Re: Proposed Coal Ash Waste Landfill
Ameren – Labadie Power Plant
Franklin County, Missouri

**Ameren Missouri
Labadie Energy Center
Franklin County, Missouri**

Groundwater Monitoring Application Review

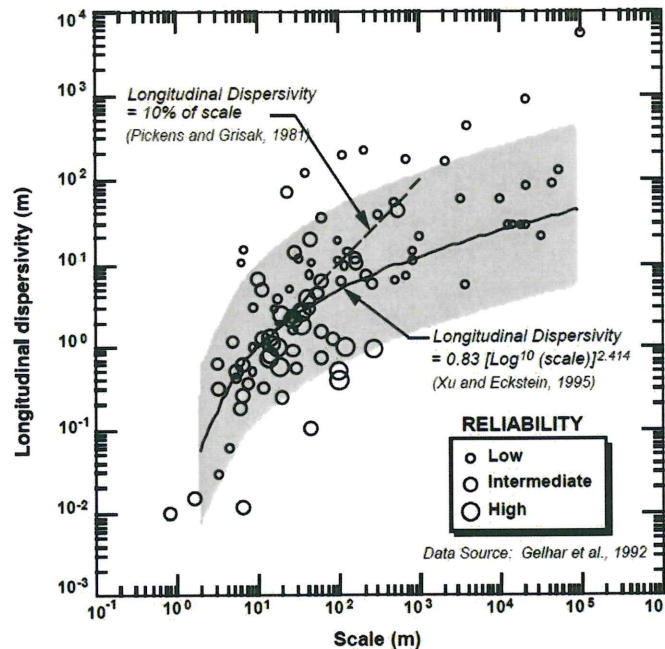
As a rule of thumb, the U.S. EPA suggests that longitudinal dispersivity can be initially estimated as 10 percent of the plume length (Wiedemeier, et al. 1998; Aziz et al. 2000). This assumes that dispersivity varies linearly with scale. However, based on a study by Xu and Eckstein (1995) of data collected by Gelhar et al. (1992), longitudinal dispersivity is best represented by the relationship:

The relationship of Gelhar (1992) and Xu and Eckstein (1995) are illustrated in the figure below.

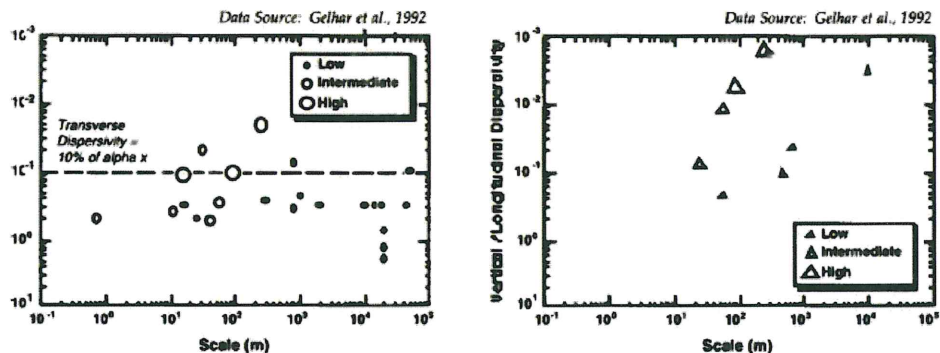
In addition to longitudinal dispersivity it is necessary to estimate transverse dispersivity. Based on the high reliability points from Gelhar et al. (1992) the transverse dispersivity may be calculated as 1/10th the longitudinal dispersivity or $a_y = 0.1 a_x$.

44 YEAR PLUME FOR CELLS 1 & 2

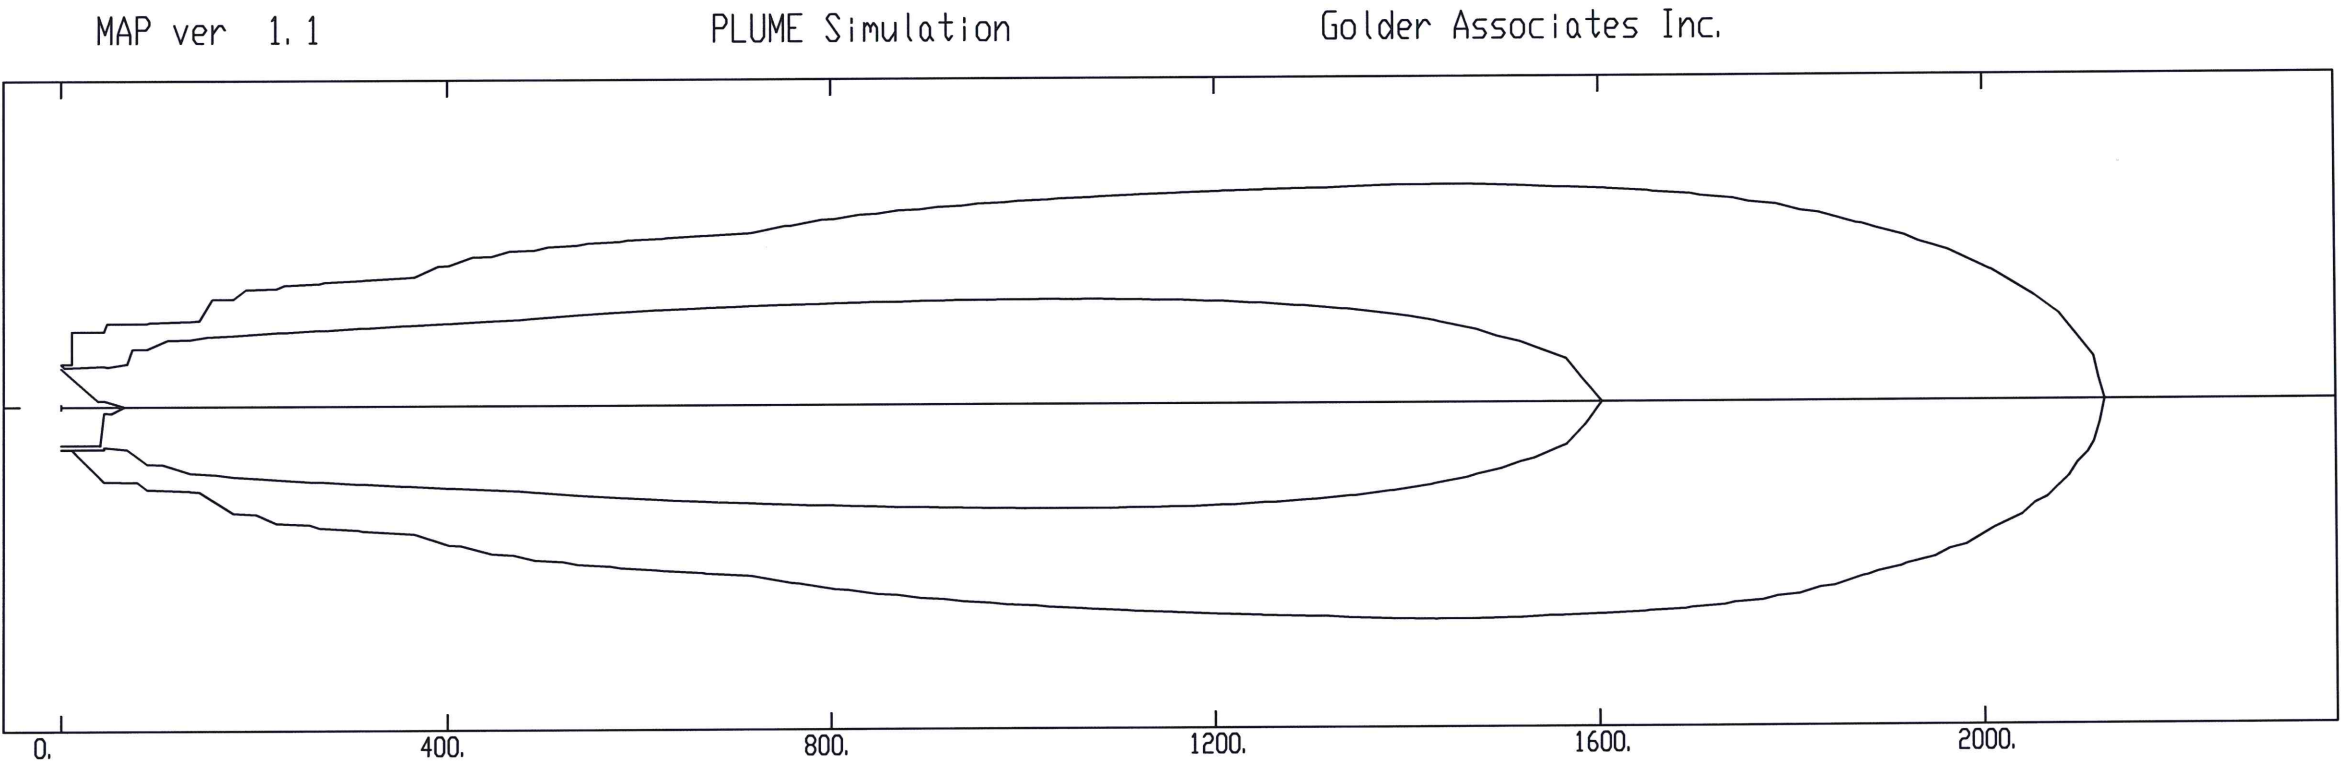
Sheet 1 in Attachment 1, (Draft Comments to Gredell) depicts the 0.001, 0.01 and 0.1 concentration contours for Cells 1 and 2 using the parameter values suggested herein. Sheet 1 is for a time period of 44 years (528 months). As depicted in Sheet 1, the 0.001 concentration contour extends to a distance of 2125 feet.

PLUMES EVALUATION	
PLANS PREPARED FOR FRANKLIN COUNTY FRANKLIN COUNTY, ILLINOIS	
DATE:	APRIL 2013
PROJECT ID:	2012-106
SHEET NUMBER:	2

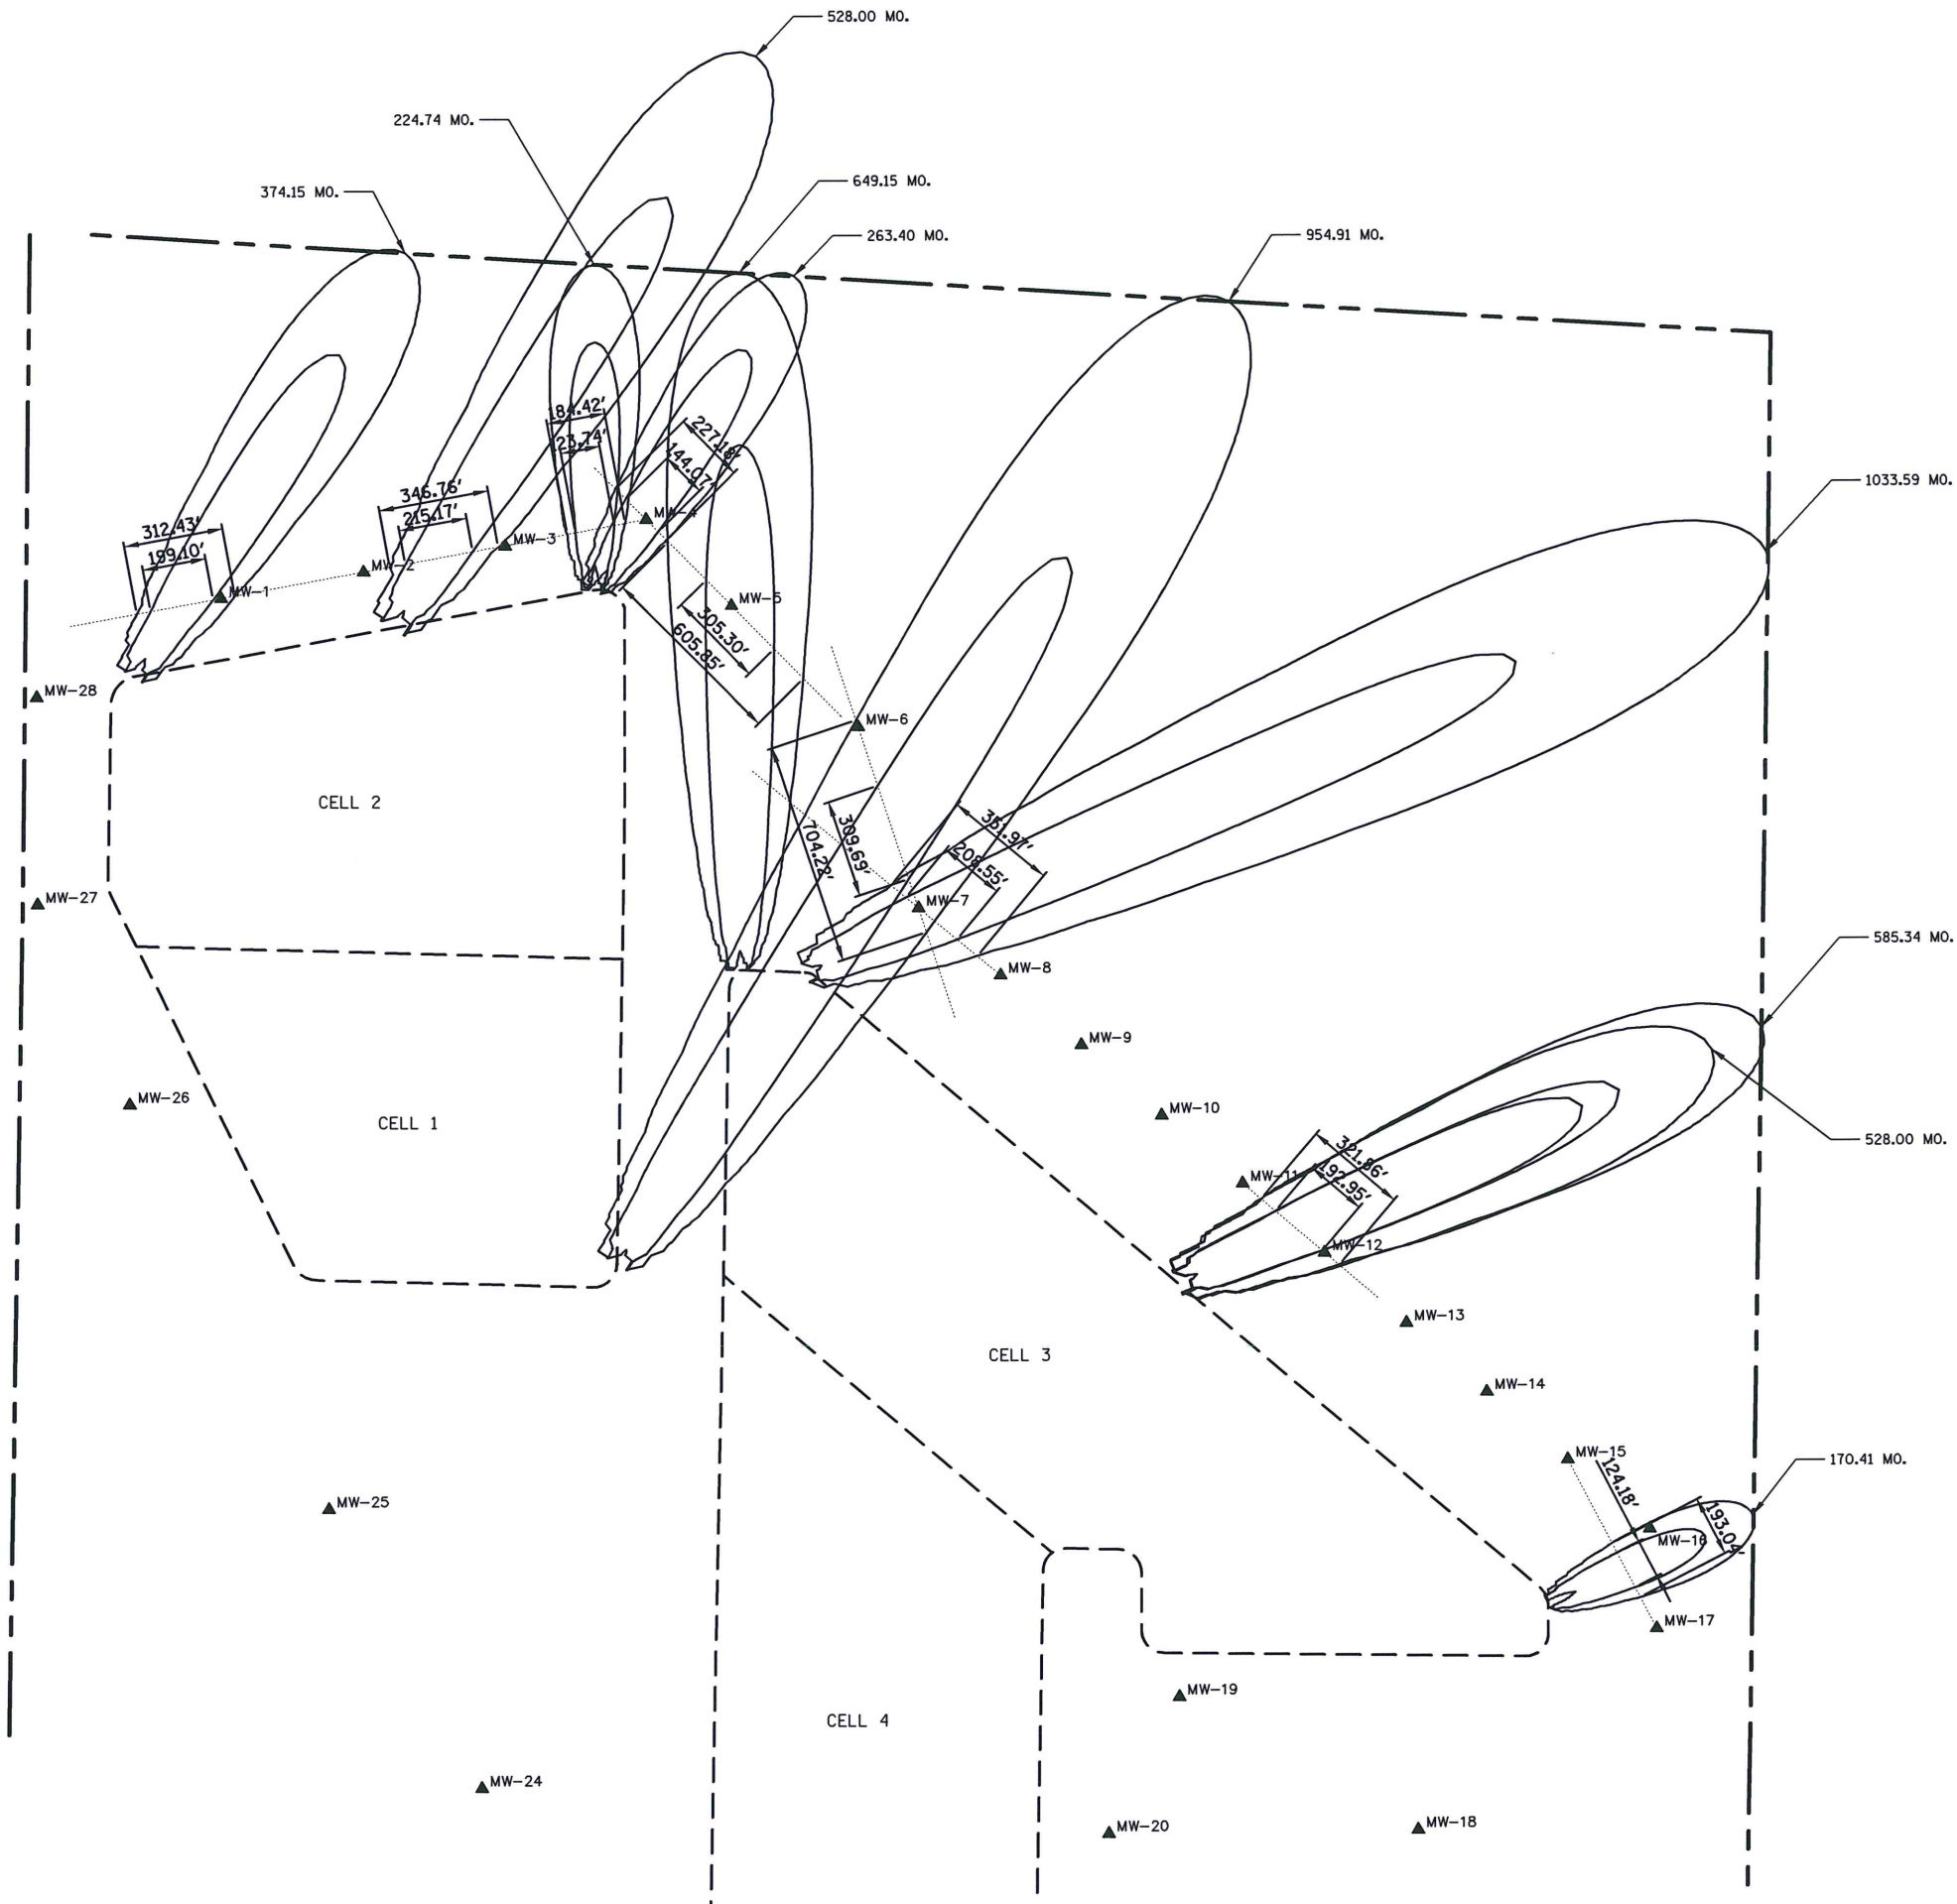
Using conservative parameters described in Section 2 above, PLUME was used to determine well spacing for Cells 1 and 2 and Cells 3 and 4. The plumes are depicted on Sheet 2 of Attachment 1 (Draft Comments to Gredell). Based on Ameren's data, the plume azimuth for Cells 1 and 2 is 32.6 degrees and for Cells 3 and 4 the flow azimuth is 66.6 degrees. As depicted on Sheet 2, the predicted plume widths are considerably smaller for the 0.01 and 0.1 concentration contours than proposed by Ameren. Given the proximity to the property boundary along the north edge of Cell 2 and along the southeast edge of Cell 3, additional wells are being recommended. The locations and depths of the additional wells are discussed below.

Monitoring wells MW-1 through MW-4 along the north side of Cells 1 and 2 are located approximately 180 feet from the waste boundary and have an approximate spacing of 450 feet. Along the described flow azimuth of 32.6 degrees, the wells are approximately 261 feet from the waste boundary. Using this flow distance, a well spacing for the 0.01 concentration contour

would be approximately 200 feet at the northwest corner and decreasing to approximately 145 feet along the northeast corner.

Based on the depicted plume widths, it is recommended that seven additional wells be installed along the north and northeast edges of Cell 2. As depicted on Sheet 3, wells P1, P2, P3S and P4 are proposed at locations 492 feet from the waste boundary, offset from wells MW-1, MW-2, MW-3 and MW-4. Wells P5 and P6 are located northeast of Cell 2 and are located 303 feet from the line of wells MW-4, MW-5 and MW-6. Wells P1, P2, P3S and P4 are spaced 450 feet apart and are offset from wells MW-1, MW-2, MW-3 and MW-4. Wells P5 and P6 are spaced 450 feet apart and are offset from wells MW-4, MW-5 and MW-6.
